NOTICE OF VIOLATION

On July 23, 2024, Energy Safety conducted an inspection of Southern California Edison Company's WMP initiatives in the vicinity of the city of Lake Elsinore, California. The inspection report is enclosed herewith. Energy Safety found the following violation(s):

INSPECTION REPORT

Exhibit A: Photo Log **Structure ID:** 4058947E

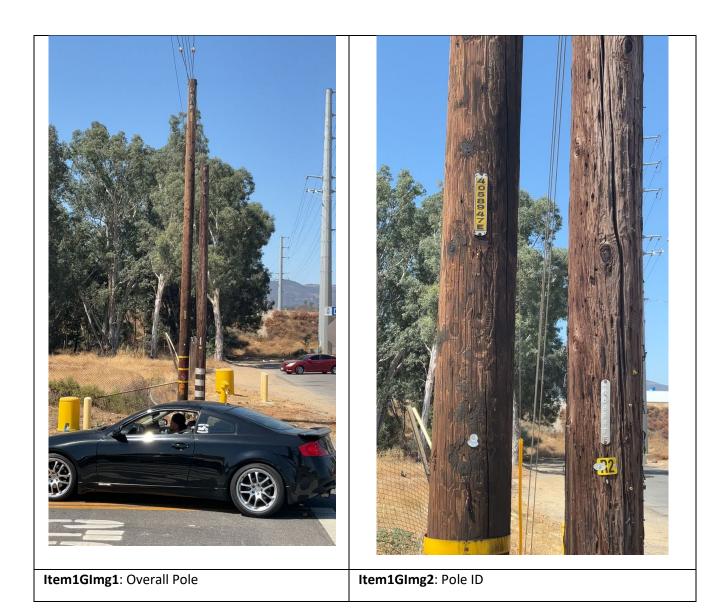
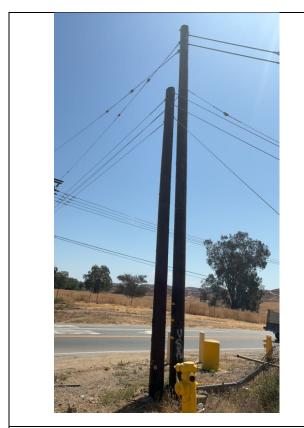
On Pole ID 4058947E, Grid Hardening ID TD2121976-4058947E, at 29546-29614 3rd St, Lake Elsinore, CA, 92532, USA, 33.69012920547379, -117.3336756193877 the inspector observed that no covered conductor was present. The inspector's observation is documented in Violation 1 photographs, which are attachments to this report. Photo numbers Item1Glmg1, Item1Glmg2, Item1IA1Img1, Item1IA1Img2 depict that no covered conductor was installed at the location.

Item1IA1Img2: No Covered Conductor Present
